Recall Campaign

NHTSA#: 17V-037
TC#: 2017-106

Date of Publication: March 2017

Replace Outside Range Gas Valve Handle and Inspect drawer
Adjust Drawer when inspection confirms too low

FIG 5: Remove 6mm nylon lock nut with 10mm socket.

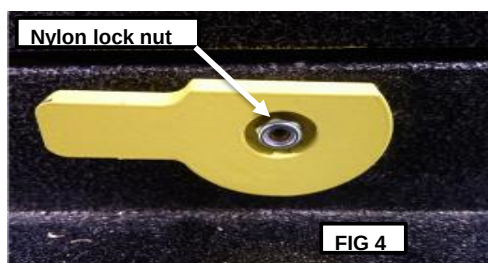
FIG 6: Remove old style handle and nylon lock nut and discard.

FIG 7: Install the new style handle.

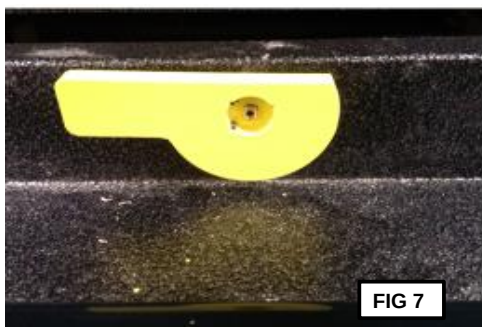
FIG 8: Prep the 6mm "keps nut" by inserting into 10mm socket.

FIG 9: Install the 6mm "keps nut" by hand until snug.

FIG 11

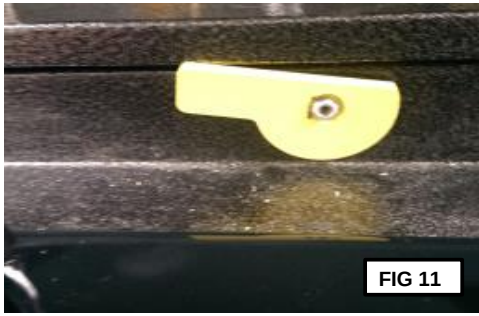
FIG 11: Verify operation. Check gas valve handle and ensure burner is extinguished before valve handle orientation allows for drawer storage.

FIG 12

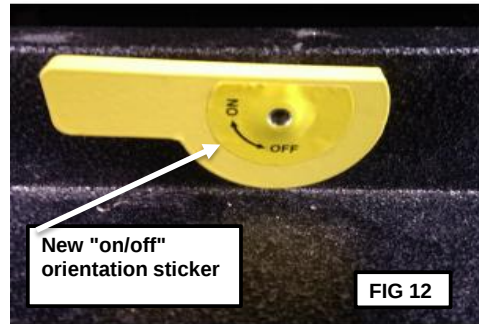
FIG 12: Install new orientation sticker (on/off sticker).

FIG 13

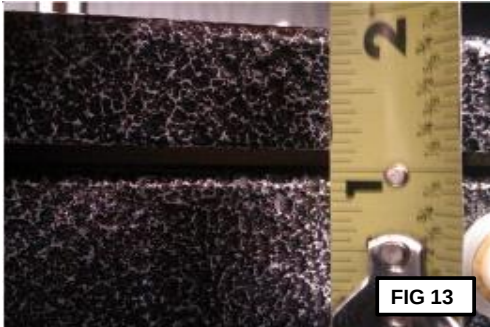
Important: the measurements of the drawer must be as noted below to ensure the drawer can not be closed with the gas valve handle in the open position.

FIG 13: Measure back splash of drawer in relation to front counter fascia. Drawer opening should be 1/8" +/- 1/16".

FIG 14

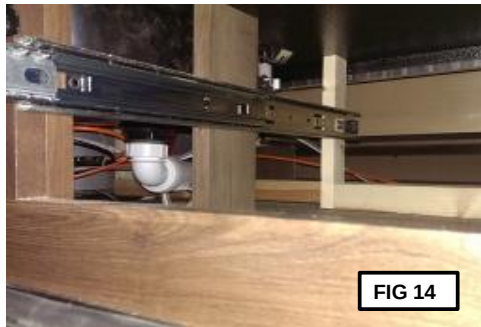
FIG14: If back splash of the stove assembly is too low, pull out drawer guides and adjust guide rails as needed.
